**EPA Superfund
Explanation of Significant Difference
for the Record of Decision:**

**Bangor Naval Submarine Base,
Site A, Bangor, WA
7/18/1994**

**EXPLANATION OF SIGNIFICANT DIFFERENCES (ESD)
FOR SOIL AND GROUNDWATER REMEDIATION CHANGES
SITE A
SUBASE, BANGOR
BANGOR, WASHINGTON**

Site A Vicinity Map

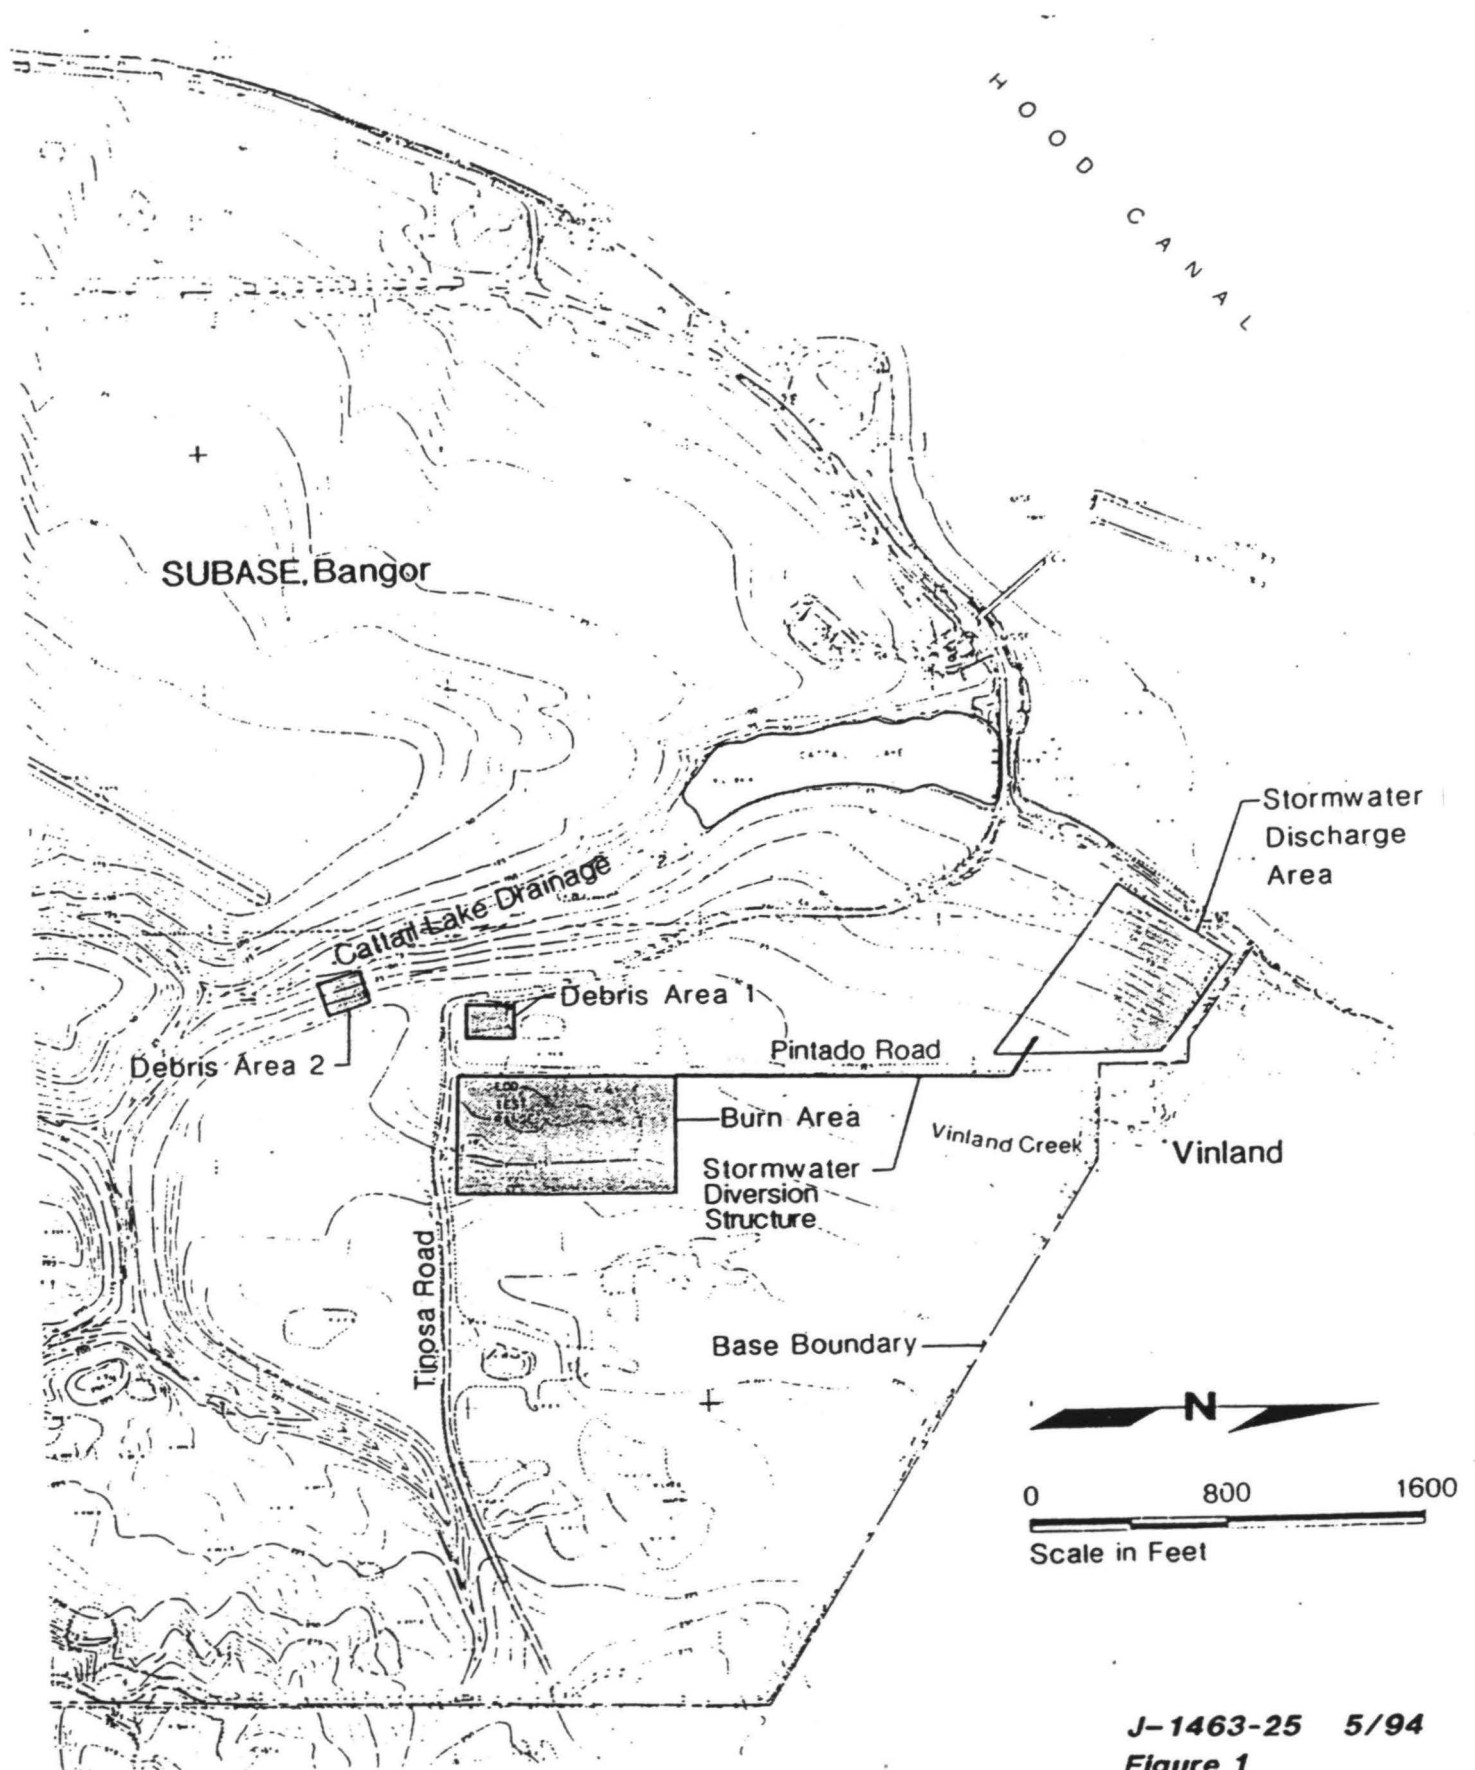
Debris Area 2 is located in a steeply sloping, heavily wooded drainage area containing significant undergrowth. The slope incline is estimated to be 0.75 horizontal to 1.0 vertical. A stream at the bottom of the slope flows into Cattail Lake, which is located approximately 100 yards further down the drainage (Figure 1). The Cattail Lake basin supports sensitive flora and fauna habitats.

Based on the above information, it is now proposed that the lead-contaminated soil at Debris Area 2 be left in place. Potential damage to sensitive habitat in the Cattail Lake basin may result due to soil erosion if soil excavation occurs. The volume of contaminated soil is relatively small, and the maximum contaminant (lead) concentration detected in that soil exceeds the cleanup standard by less than a factor of three. The contaminant is effectively bound to the soil, and therefore presents no significant risk to groundwater. The overall risk to human health and the environment associated with excavating the soil is judged to be greater than the risk associated with leaving the soil in place.

Institutional controls will be implemented to restrict future access to the Debris Area 2 slope. These controls will include a combination of barriers (e.g., fences, blackberry bushes, etc.) and warning signs. In addition, the SUBASE, Bangor, Master Plan will be revised to restrict future residential development in the vicinity of Debris Area 2.
